Appendix G Response to Comments

Subject: US Highway 101/State Route 46 West Interchange Modification Project
SCH#: 2008051102

U.S. ROUTE 101 (US -101)/STATE ROUTE 46 (SR-46) WEST
INTERCHANGE MODIFICATION PROJECT

Alternative 1 Conceptual Landscape Exhibit Shown at Public Hearing

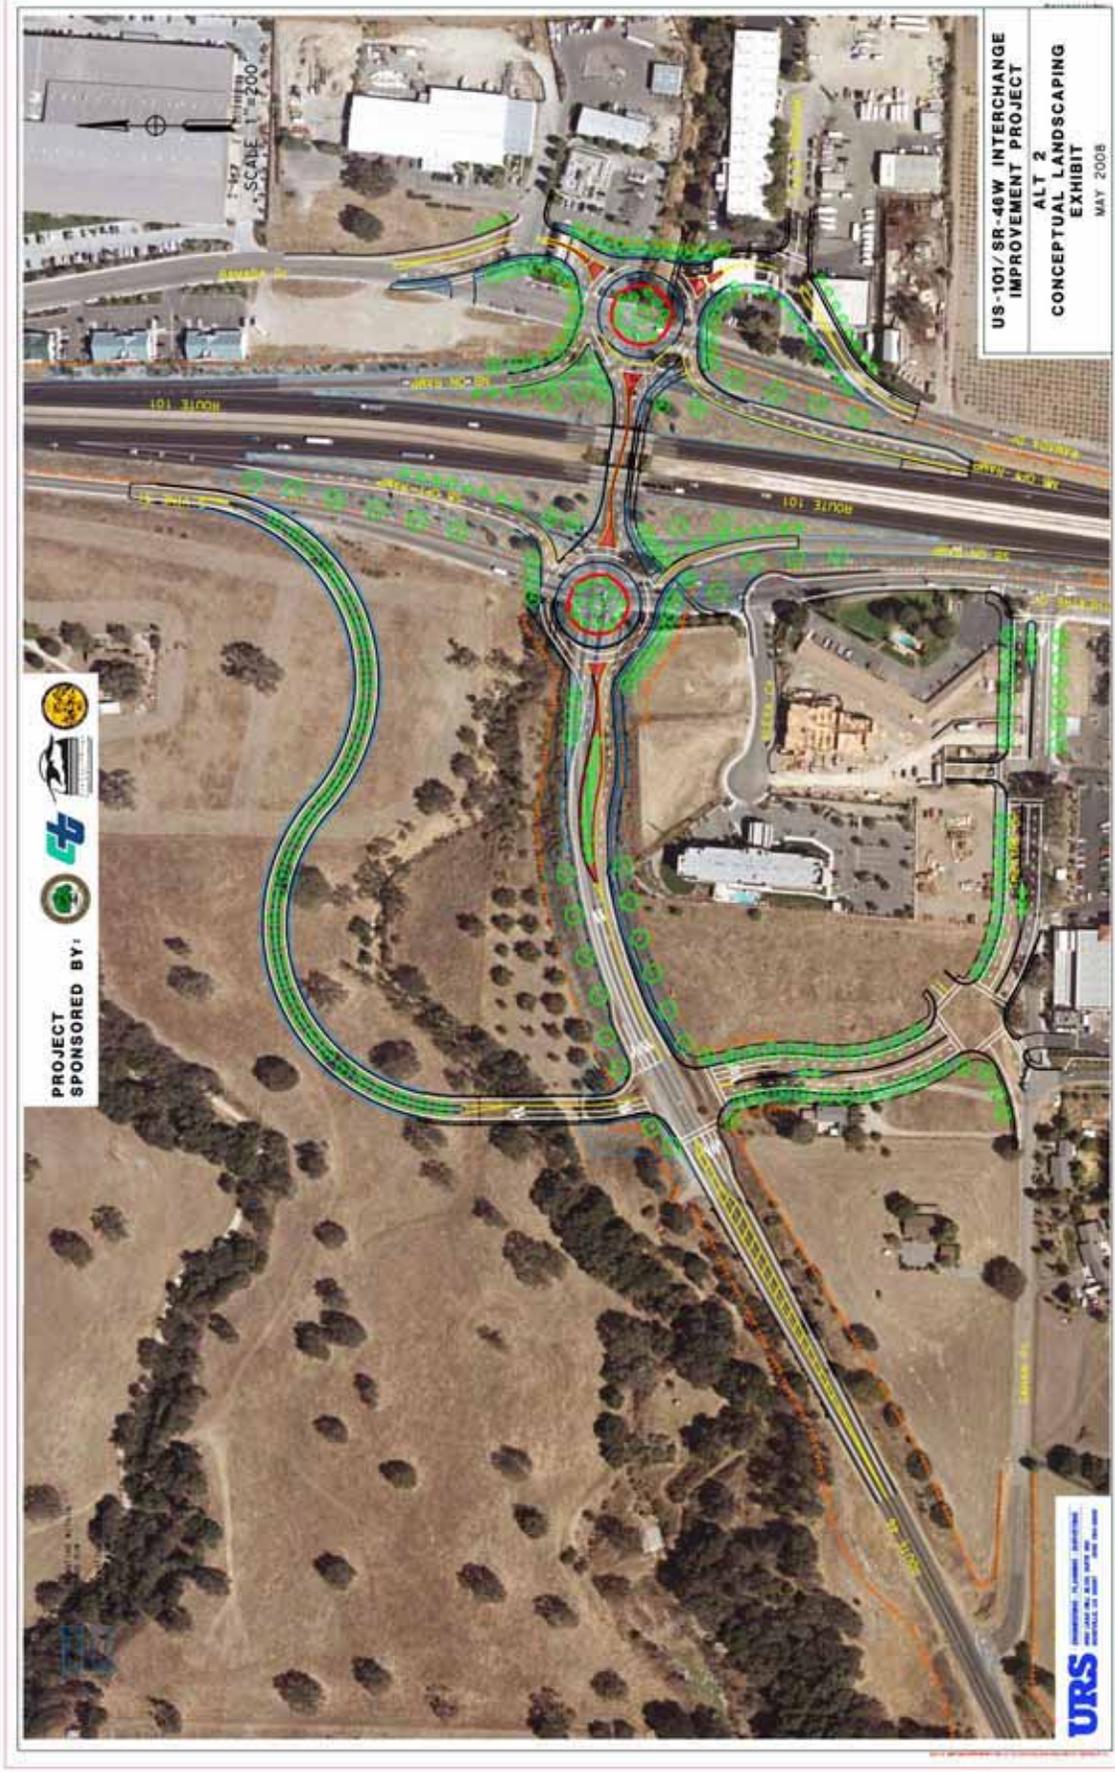
After reviewing the Visual Impact Assessment prepared by URS, the mitigation measures proposes for Key View 1 seem fairly vague. Page 6-3 states, "As part of project mitigation, formal landscaping would be introduced." What exactly does that consist of? I would like to have seen a visual simulation of KV1, not just KV2 and KV4 which were the only ones included in the report. Although the landscaping mitigation measures were vague in the Visual Impact Assessment, all of the above concerns may be effectively addressed through proper landscaping. Perhaps any dirt excavated from the site can be made into berms on the western corner of the Theatre Drive turn with large trees planted on top.

Conceptual landscaping exhibits were prepared for the public hearing held June 25, 2008, and copies of the conceptual landscape exhibits from the public hearing are attached at the end of this response. The simulations included in the Visual Impact Assessment were prepared for selected key views in consideration of the conceptual landscaping areas being proposed. The simulations comply with guidance referenced in Section 3.1 “Federal Highway Administration Guidelines” that is listed by Caltrans for California Environmental Quality Act/National Environmental Policy Act compliance on the Standard Environmental Reference web page (<http://www.dot.ca.gov/ser/guidance.htm>). The simulations included were specifically determined to be needed based on a combination of the relatively higher volumes of viewer exposure, areas proposed for relatively substantial change in form, and for which potential visual impacts were identified. Per this guidance, the degree of change in visual resource at view KV1 was determined not to require a simulation because of the following factors: the area is currently developed with commercial and roadway facilities; the unity of character will not be substantially changed; and landscaping along the street perimeter is expected to further mitigate street visibility.
